ATLANTIC COAST PIPELINE, LLC
ATLANTIC COAST PIPELINE
Docket No. **CP15-554-000 &**
CP15-554-001

DOMINION TRANSMISSION, INC.
SUPPLY HEADER PROJECT
Docket No. **CP15-555-000**

Response to Data Request
Dated April 11, 2017

Figure 25. RB0678, proposed NRHP boundary and relationship to Project

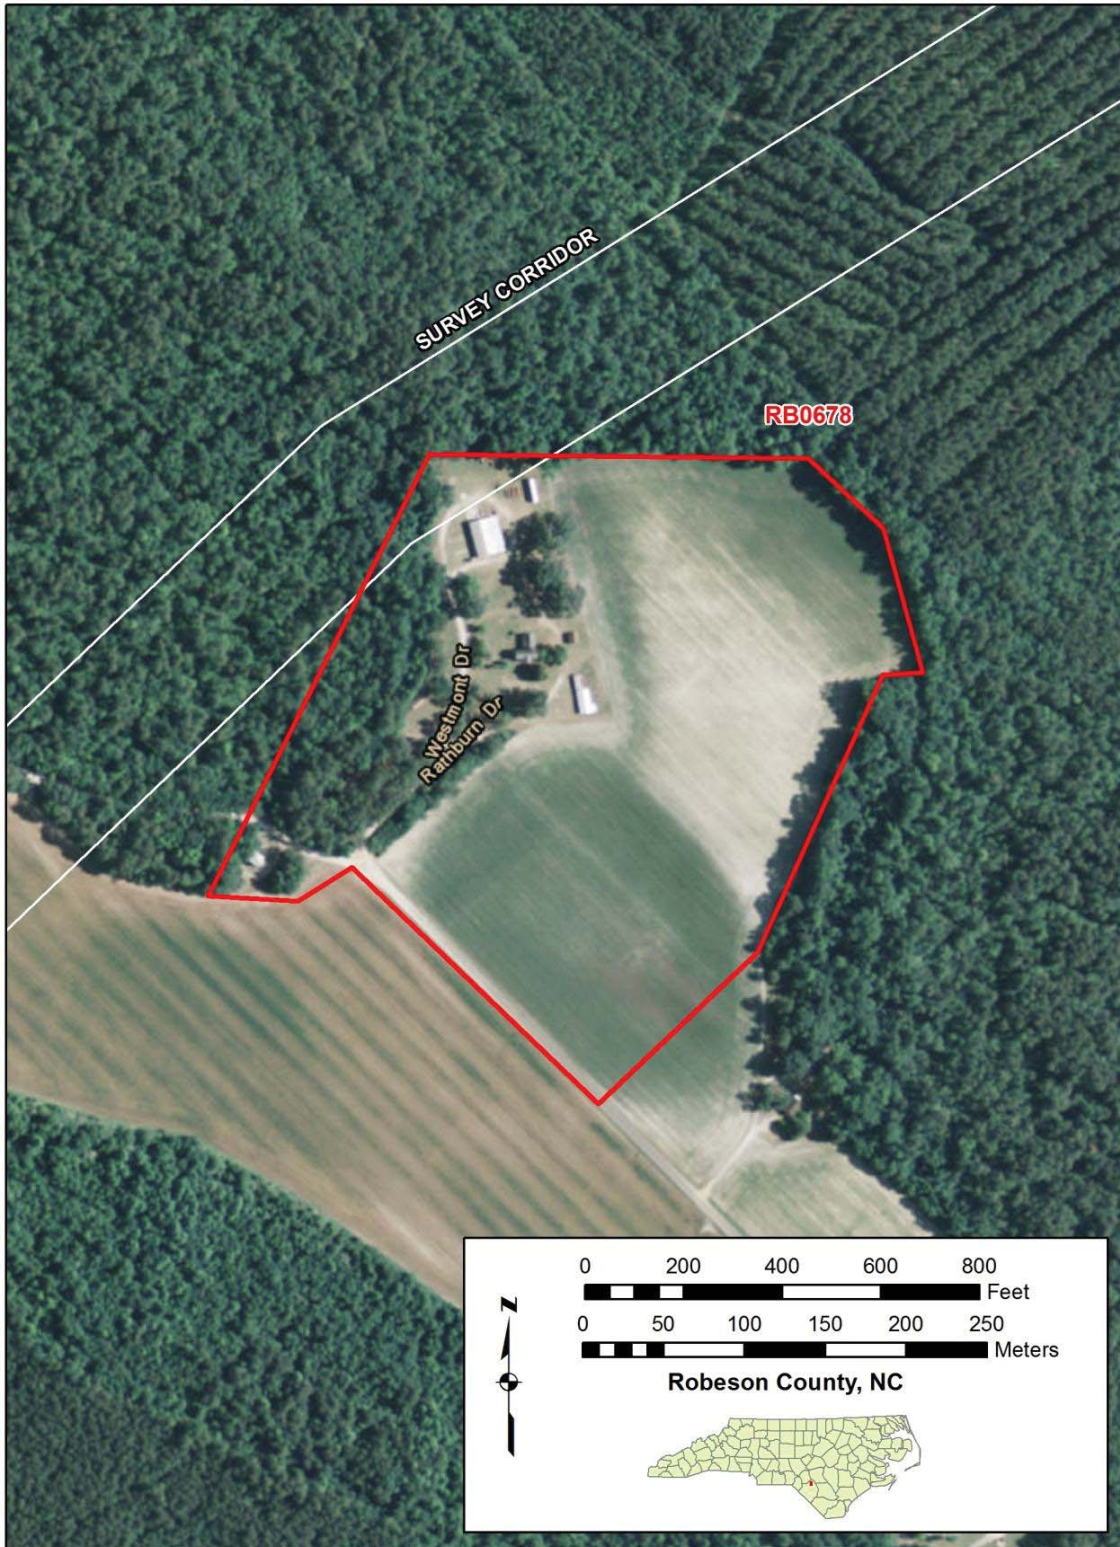
Regarding the “Phase I Historic Architectural Survey of the Atlantic Coast Pipeline Project, North Carolina Addendum 4 Report” filed March 24, 2017, provide figure 25, RB0678, proposed NRHP boundary and relationship to project, which is missing.
